GSM SERVICE SUPPORT GROUP	2002.12.09
Level 3 Schematics	Rev. 1.0
Dual Band T720 / T720i 900/1800MHz	P7.4
Ralf Lorenzen-Scheil, Michael Hansen	Page 1 of 3

Dual Band T720i/T720j 900/1800MHz 8487770N01 P7.4

Dual Band T720/T720i 900/1800MHz 848770N01 P7.4

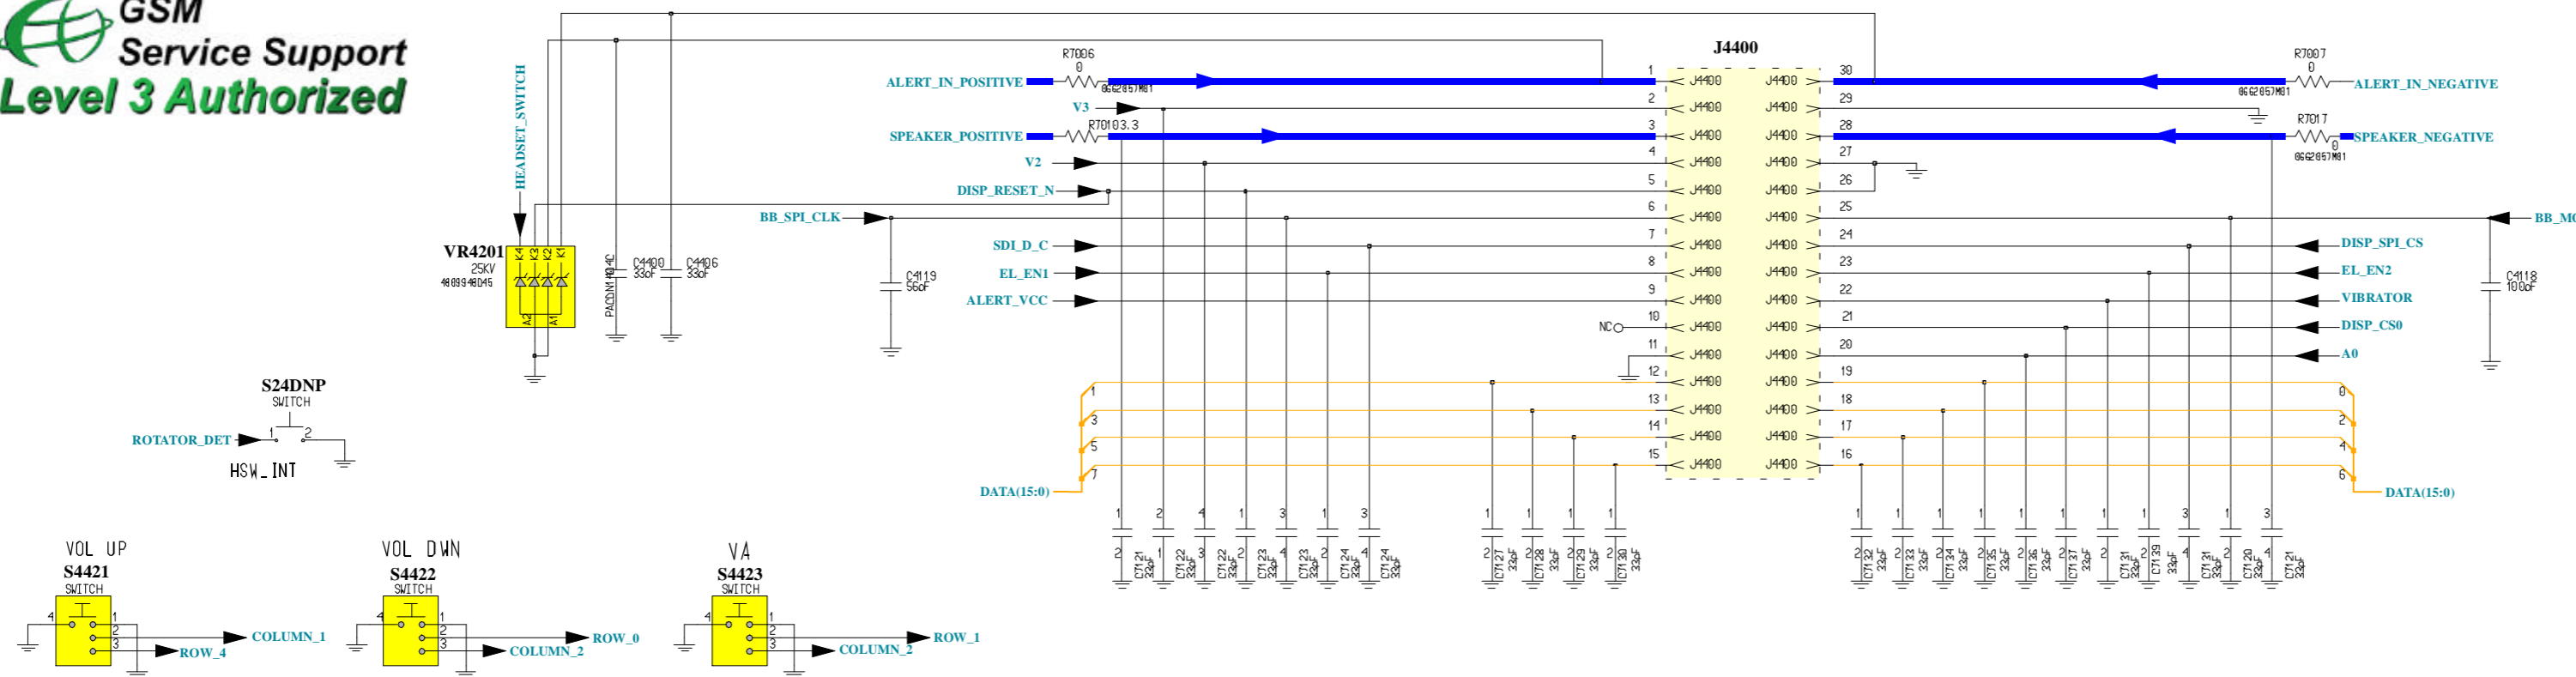
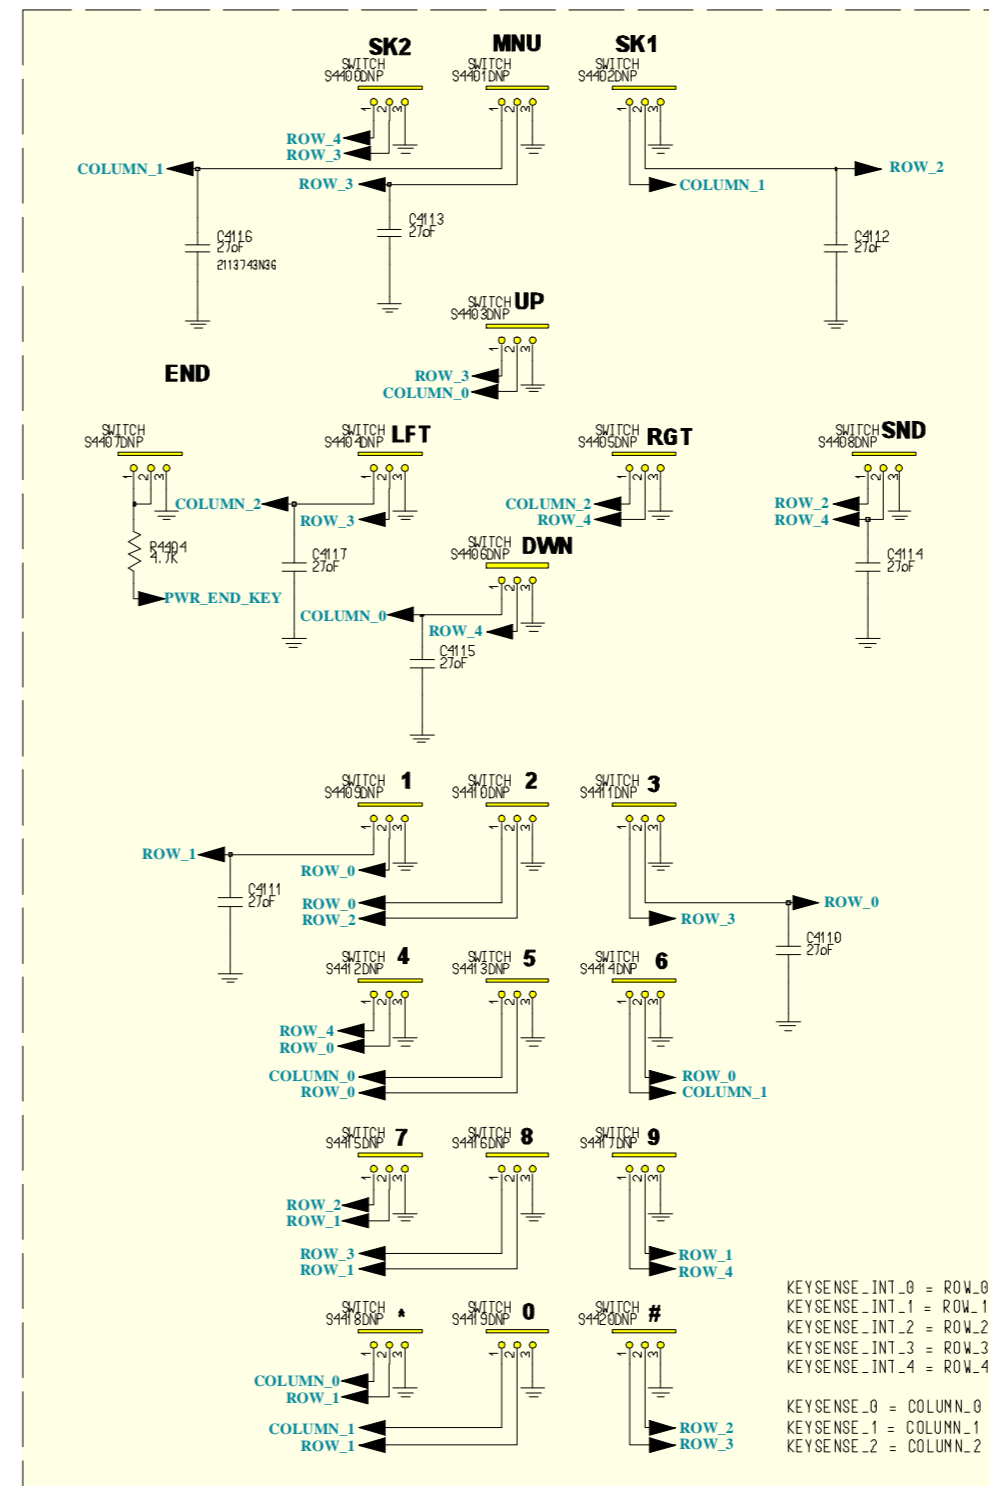
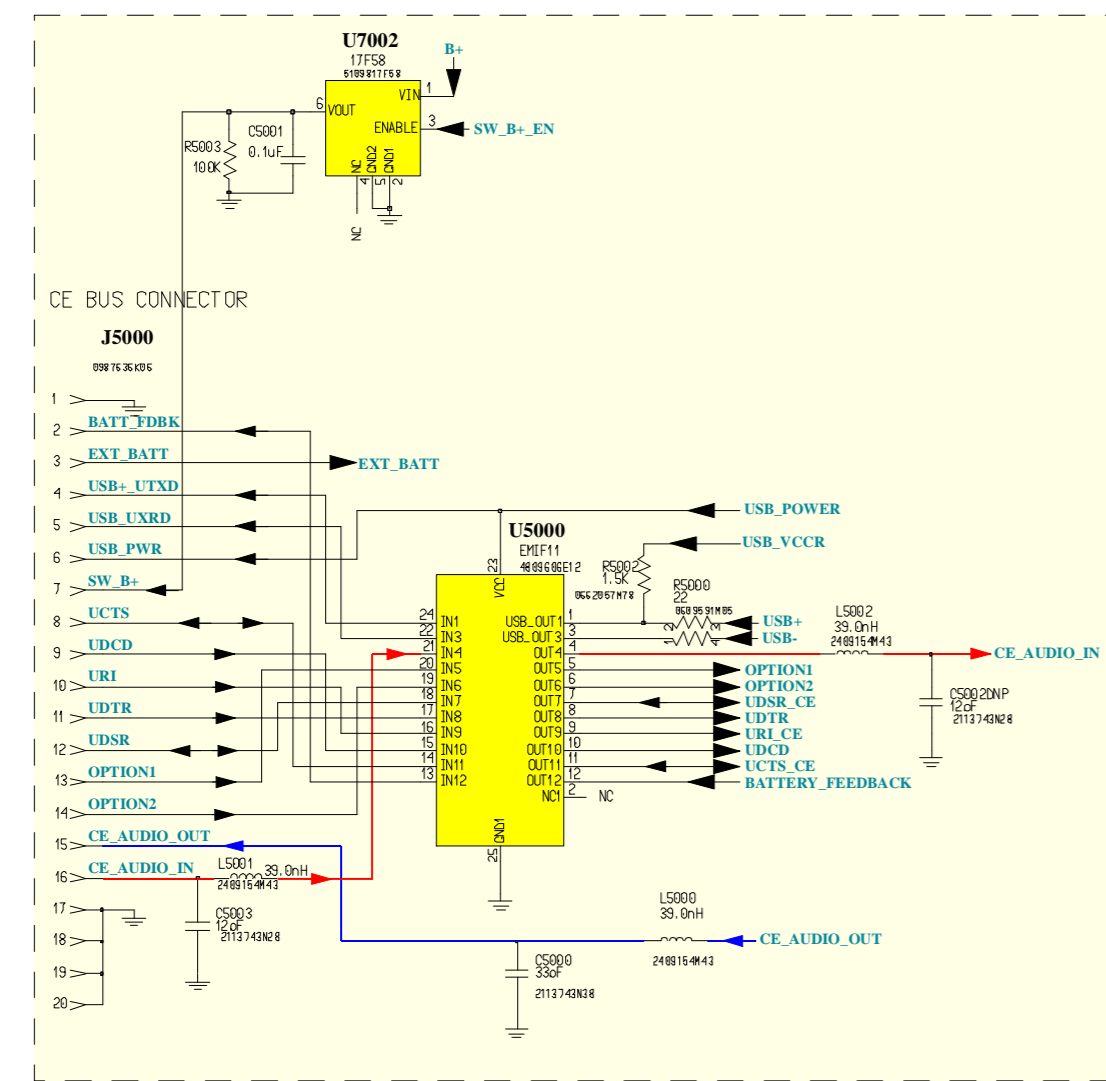
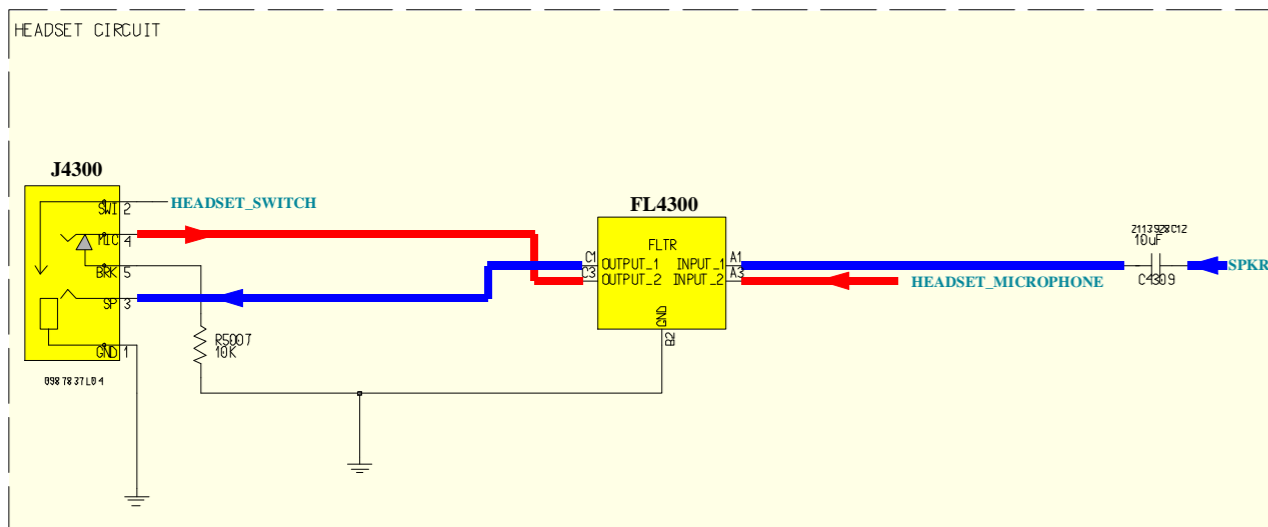
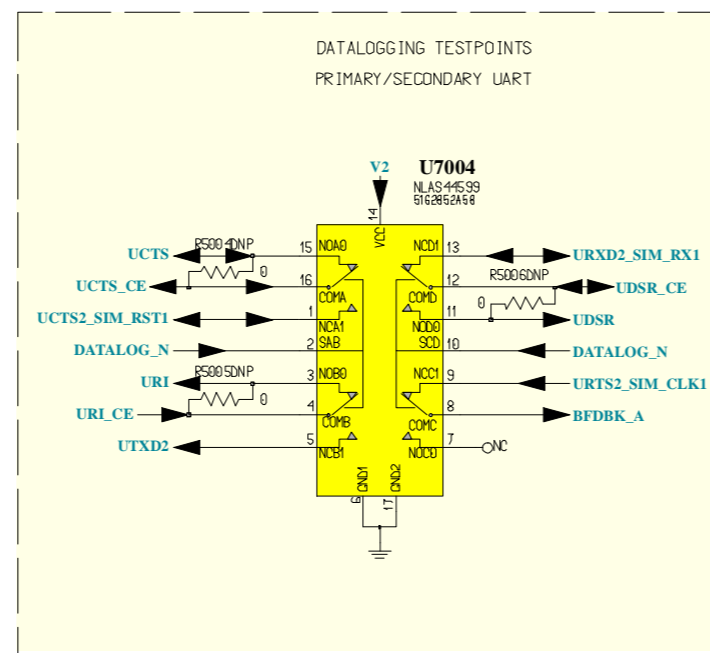
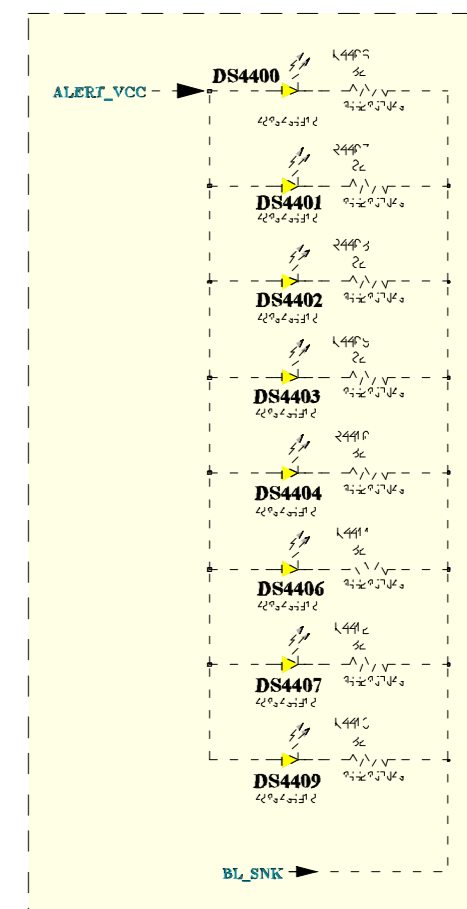
- 9-24-01 Added datalogging capability U7013
- 9-24-01 Added datalogging capability U7014
- 9-24-01 Added datalogging capability U7015
- 9-24-01 Added datalogging capability U7016

- 9-24-01 Added datalogging capability R5004DNP, R5005DNP and R5006DNP
- 12-18-01 Replaced U5000 and 5001 with single ic 480960E12
- 12-18-01 ADDED C5000 TO PROTECT CE_AUDIO_OUT line after changing CE bus esd ic

- 01-08-02 Deleted DS4408 and DS 4405.
- 01-11-02 pins 1 and 3 along with pins 28 and 30 swapped.
- 01-17-02 replaced display connector with 0987817K04
- 01-17-02 Replaced VR4201 with CAMD 0.65 mm P1488TNA24

- 01-17-02 ADDED C119 TO EL_EN2 LINE
- 01-17-02 removed VR4301 and replaced it with one comp from VR4201
- 01-18-02 Replaced U7013, U7014, U7015, and U7016 with U7004

- 02-07-02 Connected zener from VR4201 to RESET_0
- 03-05-02 Change AGND to on x one GND for buzz reduction
- 03-14-02 P6 removed VR4400 and VR4401
- 03-14-02 Added E103 to separate the HS jack ground

- 03-14-02 Added VR4402, VR4403, VR4404, VR4405, E4402, E4403, E4404, and E4405 for ESD
- 03-22-02 DELETED E_RD SIGNAL TO DISPLAY CONNECTOR, ALSO C1125 WAS DELETED

- 04 - 04 - 02 CHANGED C4400 TO C4400 AND C4406 SINGLE CAPS
- 04-09-02 Replaced L4400 and L4401 with R7006 and R7007
- 04-22-02 Added L5001, L5002, C5002, and C5003 for Buzz

- 04-23-02 E103 deleted: headset jack to have common GND.
- 04-23-02 Replaced R3501 from 5.1 to 5.6 K same as Roden
- 5-9-02 Removed VR4402DNP, VR4403DNP, VR4404DNP, and R4401

- 5-17-02 Replace R4406 to R4413 with 82 ohms 5% 0662057M48
- 5-17-02 Replaced VR4201 to 4809948045
- 6-11-02 Added DISP_RESET_N signal to reset display
- 6-14-02 ADDED C4110DNP,C4111DNP,C4112DNP,C4113DNP,C4114DNP,C4115DNP,C4116DNP,C4117DNP

- 6 - 16 - 02 ADDED C118,C4119
- 6-27-02 Place C4110,C4111,C4112,C4113,C4114,C4115,C4116,C4117 for desense
- 6-28-02 changed c4119 to n44
- 6-28-02 changed R7010 TO 3.3 OHM TO INCREASE RX AUDIO LEVEL.

- 7-11-02 Deleted R4400 and grounded pin 11 instead.
- 7-15-02 changed C5002 to DNP for buzz
